TECHNICAL NOTE			VELOCITY	
Client	Ansty Village Parish Council		Page No.	1 of 16
Project	Land Adjoining Antsy, West Sussex		Project No.	22-163
Subject	Outline Planning Application Objection		Document No	TN003
Prepared By	CWP	Checked and Authorised By	CG	Date
				Dec 2023

1.1.1 This technical note has been produced by Velocity Transport Planning ('Velocity') on behalf of Ansty Village Parish Council (the 'client') to assess the Outline Planning Application (OPA) submitted by Fairfax Acquisitions Limited (the 'applicant') for the following proposed development:

Figure 2-1: Land at Ansty: Concept Masterplan

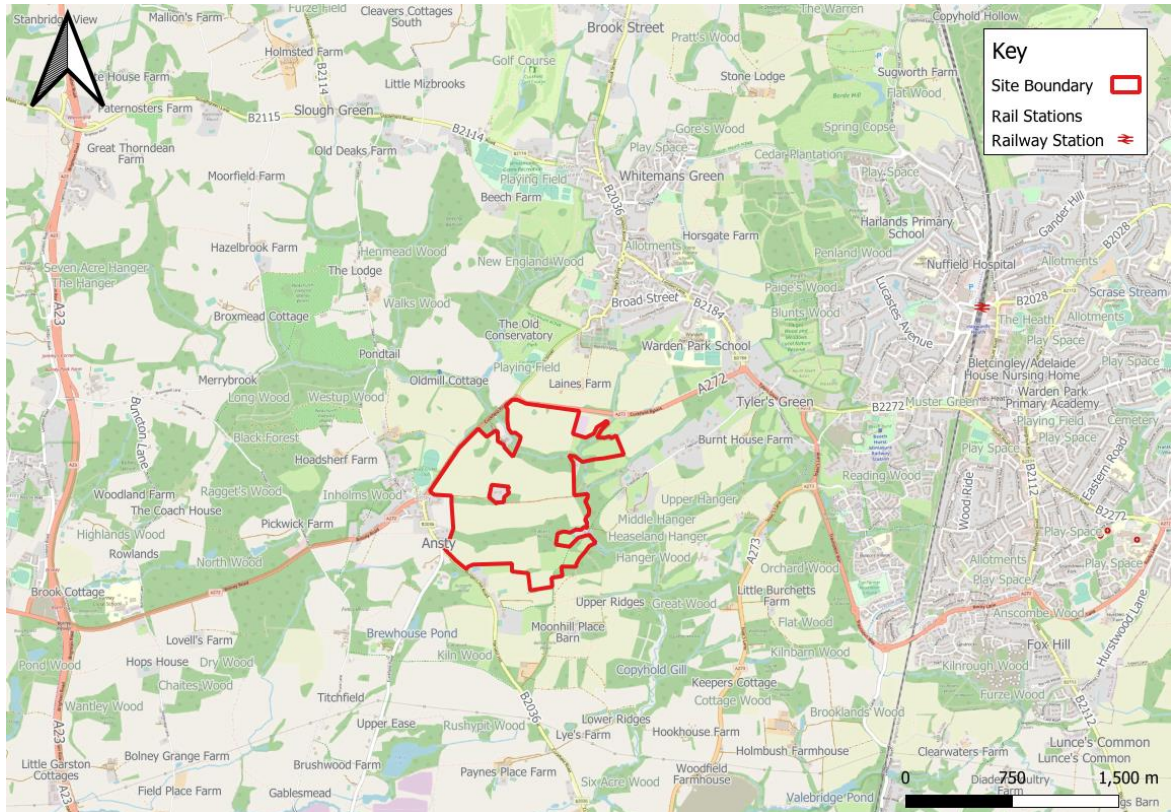
2.1.2 A copy of the Concept Masterplan included within the ACE Transport Assessment has is provided below in **Figure 2-1**, for reference purposes.
